RECALL SERVICE BULLETIN

469

Subject: Recall Campaign No.: 16V 721

Subject: FCCC Motorhome Brake Lights and Towed Device Brakes (Straight Pedal)

Fig. 1, Brake Pedal Assembly

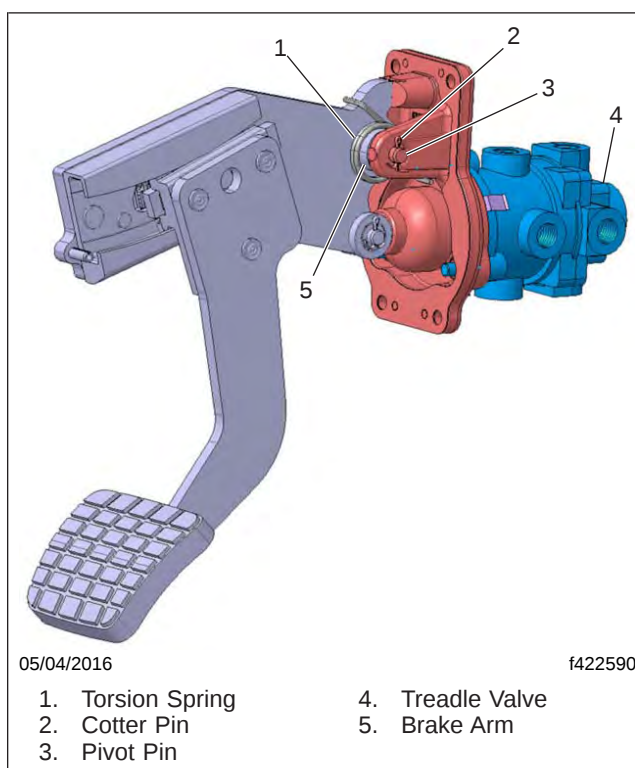
On certain motorhome chassis equipped with a certain adjustable foot pedal, the brake activation signal to the brake lights and to certain towed devices may not deactivate when the motorhome service brakes are released. This may cause the motorhome brake lights to potentially remain illuminated, and additionally may cause the brakes on the towed device to remain engaged, depending on brake configuration. A towed device with incorrectly operating brakes could increase the risk of a crash.

To remedy the issue, a new torsion spring will be added to the pedal assembly to improve the pedal return.

1. Check the base label (Form WAR259) for a completion sticker for FL723 (Form WAR260), indicating this work has been done. The base label is usually located on the front wall under the dash. If a sticker is present, no work is needed. If there is no sticker, proceed with the next step.
2. Park the vehicle on a level surface, shut down the engine, and set the parking brake. Chock the tires.
3. Inspect the brake pedal assembly for a torsion spring. See [Fig. 1](#), item 1.

4. Remove the accelerator assembly.
5. Remove and discard the cotter pin. See [Fig. 1](#), item 2.

6. Using a blunt tool, push the pivot pin out.
7. Install the new torsion spring on the service brake pedal. See [Fig. 1](#), item 1.
8. Install the pivot pin removed earlier.
9. Install the new cotter pin, bending the ends of the pin over to secure it in place.
10. Install the accelerator assembly.
11. Start the vehicle. When the air tanks have reached approximately 65 to 76 psi (448 to 524 kPa), depress and release the brake pedal several times. Exit the vehicle and verify that the brake lights are not activated.
12. Clean a spot on the base label (Form WAR259). Write the recall number, FL723, on a blank red completion sticker (Form WAR260), and attach it to the base label to indicate this campaign has been completed.
